Construction Division
Additions & Alteration Charges Approval Form

Company Name:		MRMLLP	Site	Gulmohar Residency
Name of the customer		Mr. Satish		
Villa/ Flat No.		C-406		
Sl.No	Description	Amount		
1	Total extra Charges	44,670.00		
2	Total refundable amount	—		
3	Net amount to be charges (if any)	44,670.00		
4	Net amount to be refunded (if any)	—		
Remarks :				
Approved by Project Manager		Approved by Design Team		Approved by MD
Date : 17/10/2023		Date		Date
Sign: 		Sign:		Sign:

Details of Additions & Alterations

Flat No	406 406 .	Block no.	C .
Flat Area	1660 sqft	Type	Deluxe / Luxury
Buyer Name	Sathish . S.		
Phone No.	.	Email

B-BLOCK-ELECTRICAL PLAN - PLATS NO 7-B2 TYPE

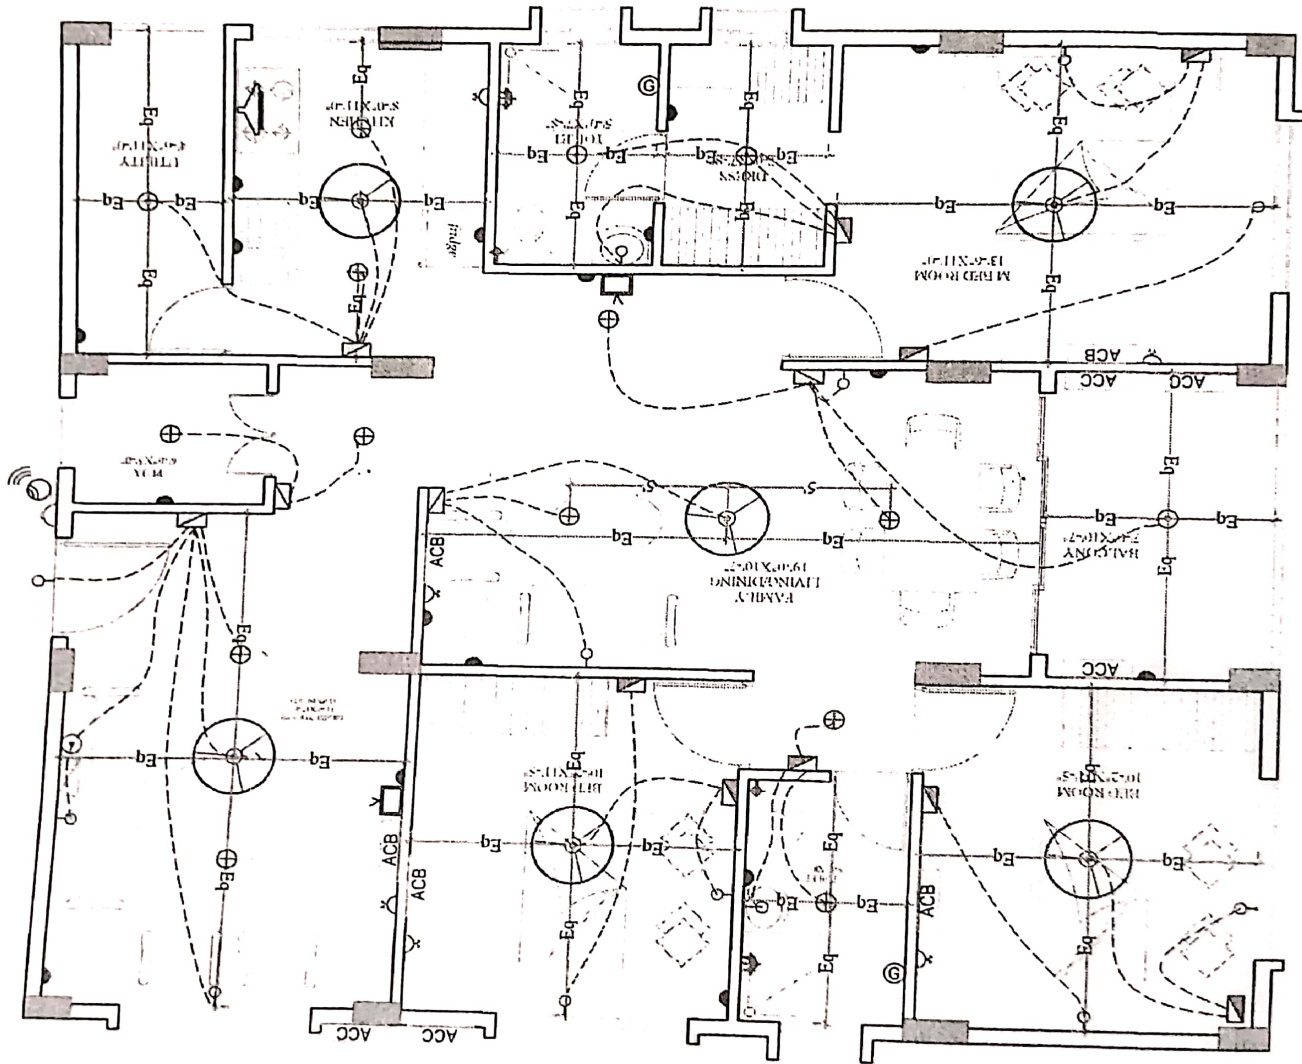
Changes in electrical points: (mark on plan)

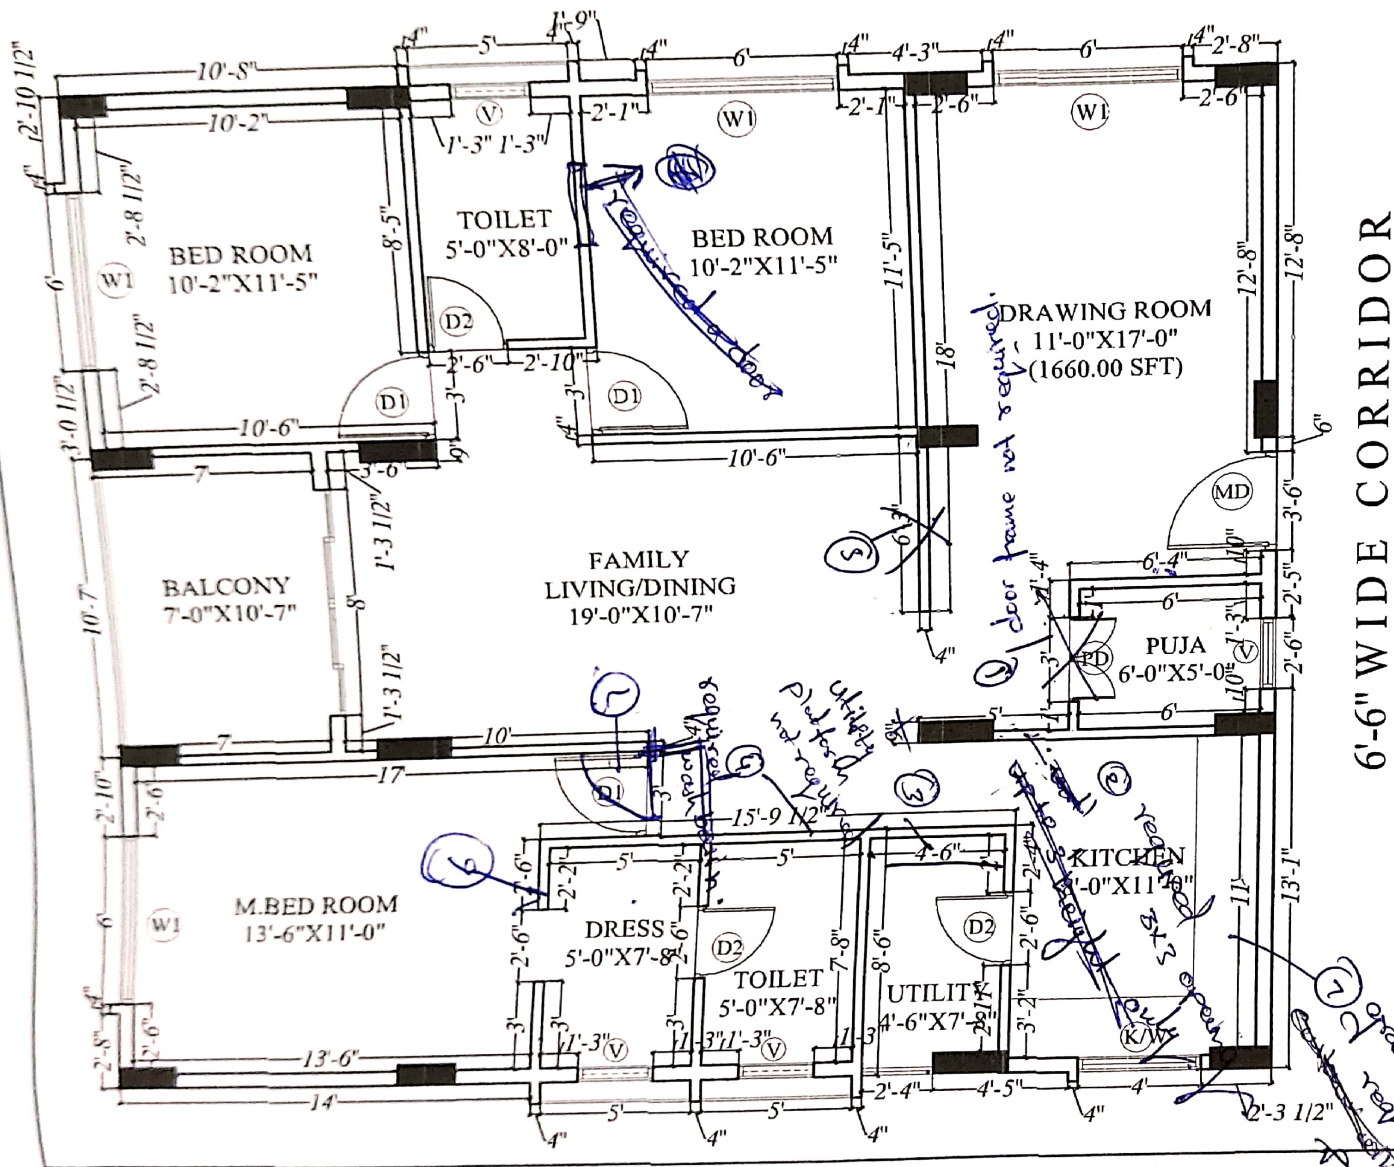
Changes in kitchen platform: (mark on plan)

kitchen granite will be provided by customer.

Changes in flooring:

- ① Isipara Barasara in. Child & nabin - B. Room
- ② Urban wood natural in Guest B. Room
- ③ living & dining - tepece ceramara.
- ④ Toilet - Common Toilet = Luna.
— Master Toilet = Luna.
- ⑤ Balcony - Country Road.
- ⑥ utility - requesting for Luna. (no need of toilets)
- ⑦
